DEPARTMENT OF PLANNING
STAFF REPORT

SPEX 2009-0005, Harvard Junior Preschool

PROPOSAL: A Special Exception for a 12,075 sq. ft. childcare/preschool center in the R-2 Zoning District of the Revised 1993 Zoning Ordinance.
Application received May 18, 2009.

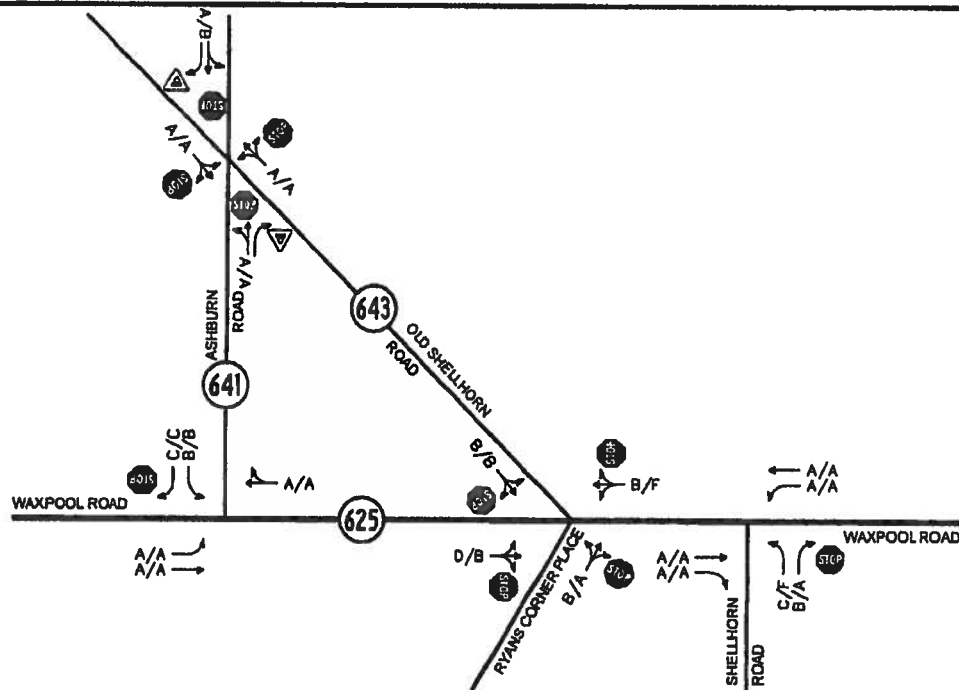
- 12.OTS concurs with the Virginia Department of Transportation's (VDOT) June 1, 2010 letter that recommended that the Applicant dedicate 25' ROW from the centerline of Shellhorn Road (Route 643), consistent with the property to the west.
